Historic Preservation Board Agenda September 1, 2016 - 4:00 PM

Certificate of Appropriateness HB 16-47 627 Crill Ave..

STAFF REPORT

Figure 4: Renovation schematic

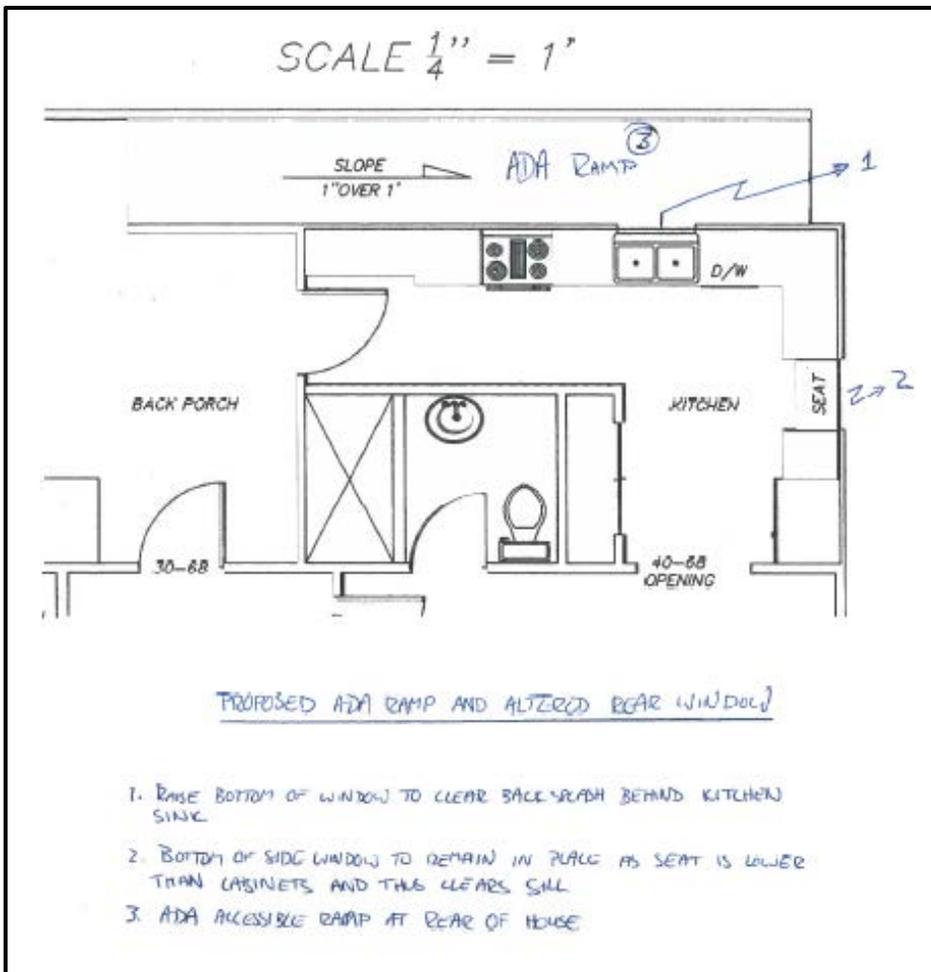
- 2) **Walkway ramp** – while such ramps were not typically utilized in historic homes, they are also sometimes a practical necessity. The Applicant noted that “the ramp will be built at the rear elevation of the house and be manufactured out of wood and the maximum elevation of the ramp is less than 20 inches. The railings will be kept to an absolute minimum with no balusters to have a minimal impact on the house's appearance. No type of screening is to be installed.” As Figure 1 demonstrates, the rear property line and Morris St. property line are fairly well screened with vegetation, and the ramp will not be very visible from the neighboring properties and from Morris St., particularly as it is at ground level and not immediately apparent to the eye.

Staff comment: applicable provisions of the Secretary of the Interior's Standards call for replacing building elements with like kind. The window shortening will still retains the verticality of the original windows on the side facades, and the ramp will utilize wood materials and limited railings. Furthermore, both features will be mostly screened from neighboring and public view.

Staff recommends approval of shortening the rear window and constructing the walkway ramp, COA HB 16-47, in keeping with the schematics presented by the Applicant, and with the understanding that the ramp present minimum visual impacts with simple railings. Recommend natural wood color for ramp so as to better blend in with the rear yard, as opposed to tying into the house color.

Figure 5: Window before

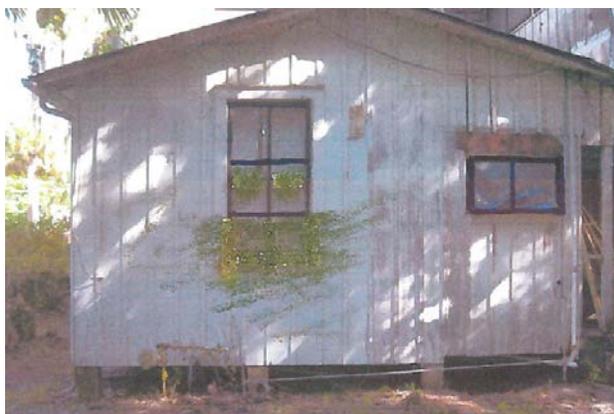
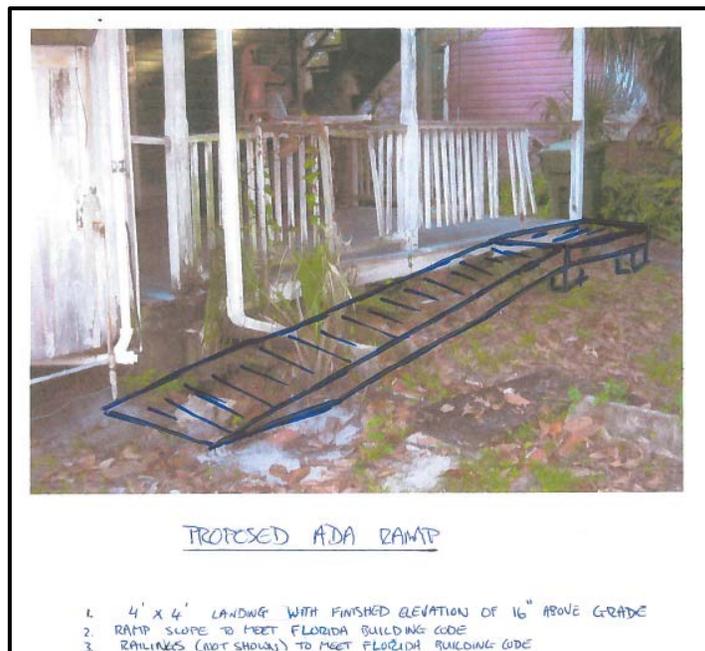
- 1) **Rear window shortening** – as in other requests, a modern functional kitchen requires more wall space than is provided in historic homes like this. Shortening the window will allow for counter space. While interior considerations are not the purview of the Board, it is helpful to understand the practical issues of cases like this. As Figures 5 and 6 below show, the shortened window would have the same arrangement of panes and would retain its verticality.
